Access Compliance Report

Public Rights-of-Way

(Curb Ramps)

Intersection ID: 22673	Main Street: BRACKENBURY_LN	Cross Street: HILLANDALE_DR	Location: NE
ADA ID: 89201ECCEF59	Ramp Type: Perp	Initial Pass/Fail: Fail	Overall Compliance: No
Severity Score: 22.5			
Codes/Mitigation Info/Possible Solution		Field Measurements/Component Compliance

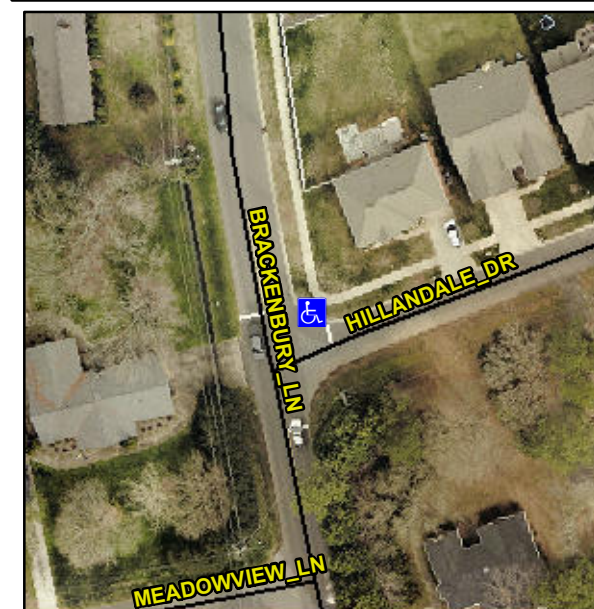
Not Found, R304.5.1, R304.2.2, R304.5.3

Compliance	Description	Data	Compliance	Description	Data
N/A	Ramp Length (in)	96.0	No	Ramp Slope (%)	8.6
No	Ramp Width (in)	47.0	No	Ramp XSlope (%)	2.2
N/A	Flare Type LT	N/A	N/A	Flare Type RT	N/A
N/A	Flare Slope LT (%)	N/A	N/A	Flare Slope RT (%)	N/A
N/A	Flare Traversable LT?	N/A	N/A	Flare Traversable RT?	N/A
N/A	Landing Length (in)	N/A	N/A	DWS Provided?	N/A
N/A	Landing Width (in)	N/A	N/A	DWS Contrast?	N/A
N/A	Landing Slope (%)	N/A	N/A	DWS Length (in)	N/A
N/A	Landing X Slope (%)	N/A	N/A	DWS Full Width?	N/A
N/A	Landing Curb? (Y/N)	N/A	N/A	DWS Offset (in)	N/A
N/A	Shared Landing?	N/A			
N/A	Gutter Ponding?	N/A	N/A	Gutter Slope (%)	N/A
N/A	Gutter Lip Ht (in)	N/A	N/A	Gutter X Slope (%)	N/A
N/A	Painted X Walk1?	No	N/A	Painted X Walk2?	N/A
	X Walk 1 Direction	To S		X Walk 2 Direction	N/A
N/A	X Walk 1 Width (in)	N/A	N/A	X Walk 2 Width (in)	N/A
	X Walk 1 Slope (%)	1.7		X Walk 2 Slope (%)	N/A
	X Walk 1 X Slope (%)	4.0		X Walk 2 X Slope (%)	N/A

Remove & Replace Entire Ramp.
